# STAFF REPORT

SUBJECT: Prairiefire  
H-2022-0053

### I. PROJECT DESCRIPTION

Annexation of 3.16 acres of land with an R-8 zoning district; and preliminary plat consisting of 22 building lots and 1 common lot on 3.16 acres of land in the R-8 zoning district for Prairiefire Subdivision.

## B. Preliminary Plat (dated: 6/15/22)

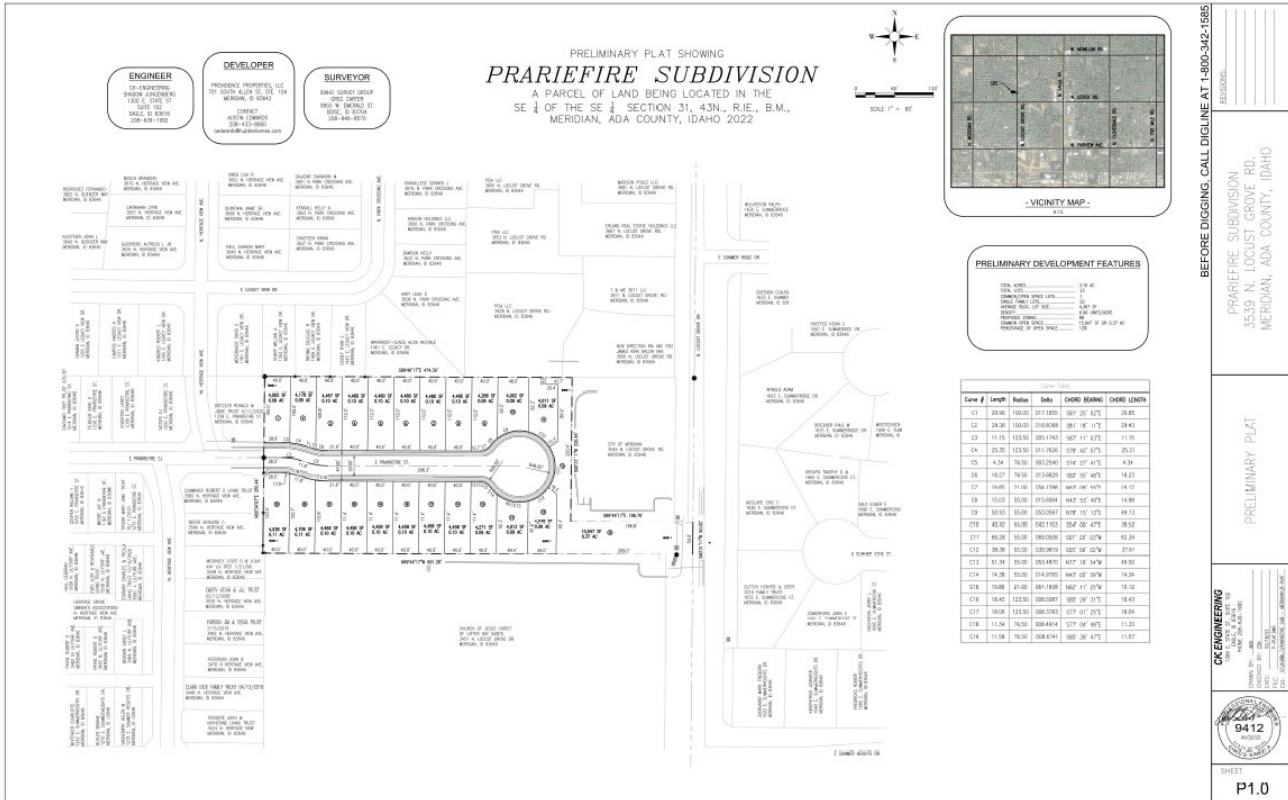
***Staff recommends that the applicant remove Lot 11, Block 1 along the northern property boundary so the lots can be widened for a better transition and provide more visibility on the pathway connection to the commercial development.***

**Staff recommends that the applicant remove Lot 11, Block 1 along the northern property boundary. The micropath connection on the northern portion of the common lot adjacent to the commercial development is hidden behind Lot 11, Block 1 creating a potential safety issue for**

**pedestrians. Pedestrian pathways on common lots shall be designed to reduce the incidence of crime and improve the quality of life.**

2. The final plat shall include the following revisions:
  - a. Remove Lot 11, Block 1 to increase the size of all lots along the northern property boundary to provide a better-quality transition with the existing homes in the Quenzer Commons Subdivision and increase visibility on the micropath connection to the commercial development to the north.

### C. Landscape Plan (dated: 6/16/2022)

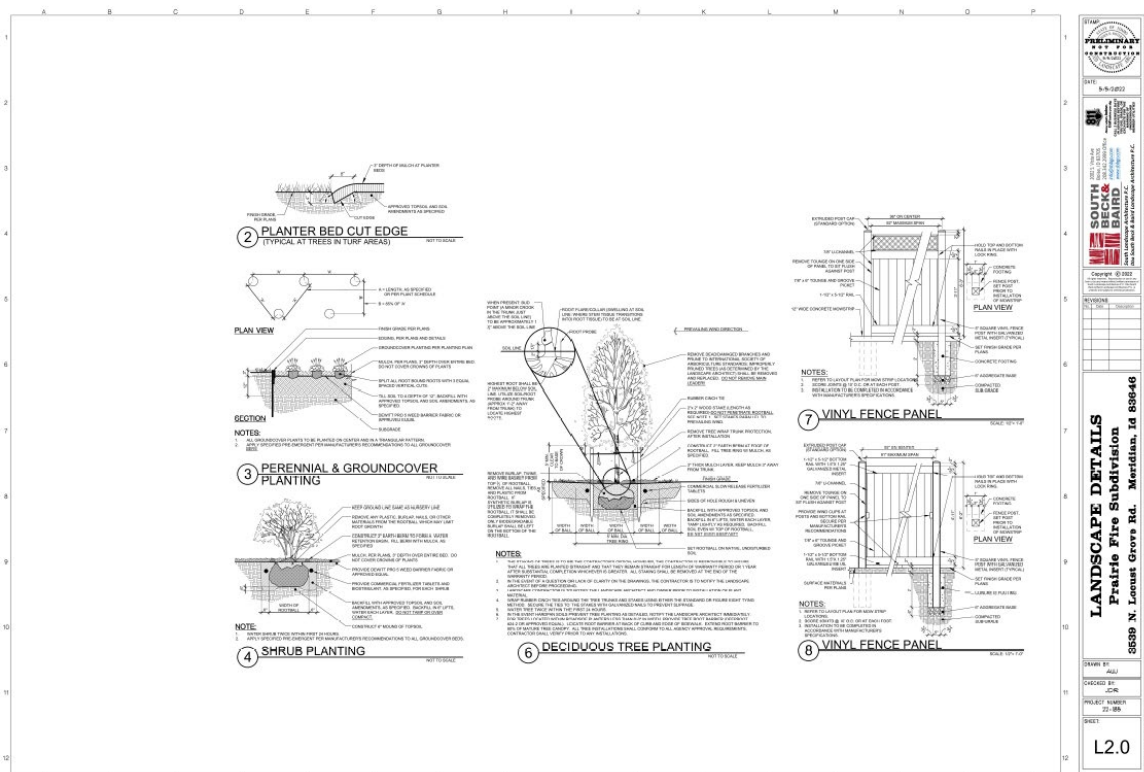
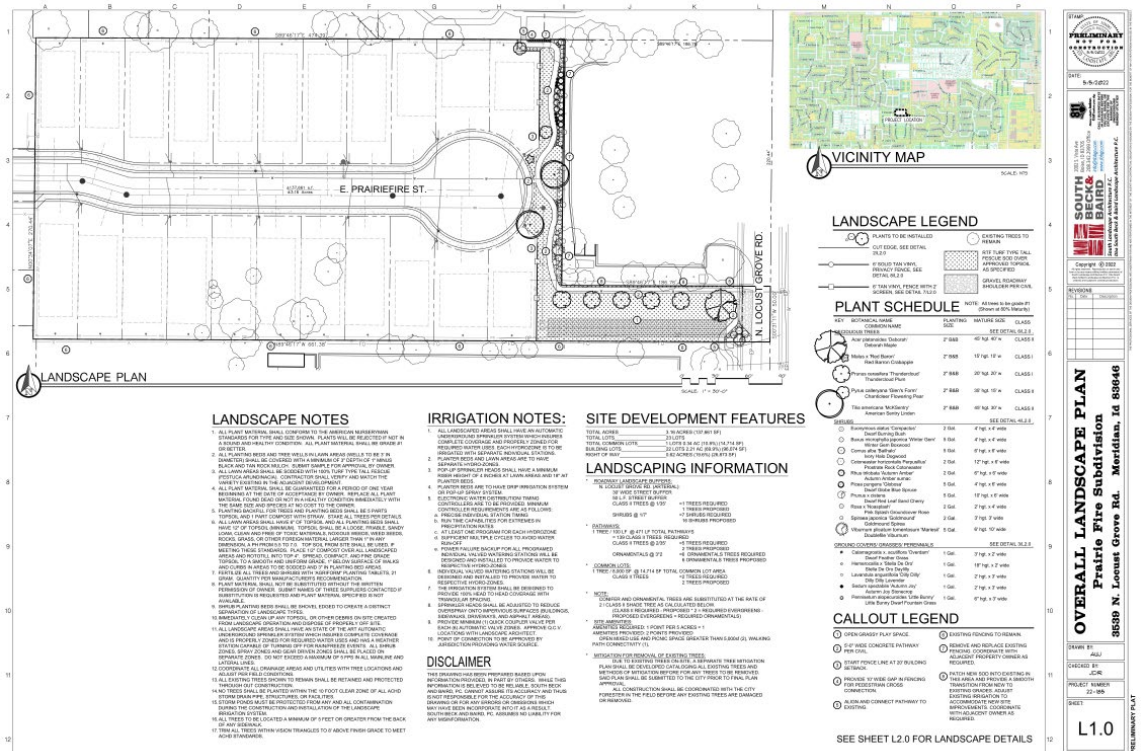
**Landscaping (UDC [11-3B](#)):** A 25-foot wide buffer is required along material roads per UDC Table [11-2A-6](#). Common open space landscaping is proposed as shown on the landscape plan in Section VIII.C. All micro-pathways shall meet the requirements of UDC 11-3B including landscape strips of at least 5-feet in width on either side and one tree per 100 linear feet per the standards listed in UDC [11-3B-12C](#); **the landscape plan should be revised accordingly.**

**Fencing:** The landscape plan includes a fencing plan. The plan includes 6-foot-high solid vinyl fencing along the western periphery of the site along the east side of common lot 12 adjacent to the adjoining commercial property; 6-foot tan vinyl fencing with 2-feet of open vision screening is depicted on one side of the common open space along the micro-pathway. The fencing appears to meet the requirements of 11-3A-6 and 11-3A-7.

3. The landscape plan submitted with the final plat shall include the following revisions:
  - a. Depict landscaping along the micropath in accord with the standards listed in [UDC 11-3B-12C](#).

- b. Remove Lot 11, Block 1 along the northern property boundary so the lots can be widened for a better transition and provide more visibility on the pathway connection to the commercial development.

- c. Include mitigation calculations on the plan for existing trees that are proposed to be removed in accord with the standards listed in UDC [11-3B-10C.5](#). The Applicant shall coordinate with the City Arborist (Kyle Yorita [kyorita@meridiancity.org](mailto:kyorita@meridiancity.org)) to determine mitigation requirements *prior* to removal of existing trees from the site.
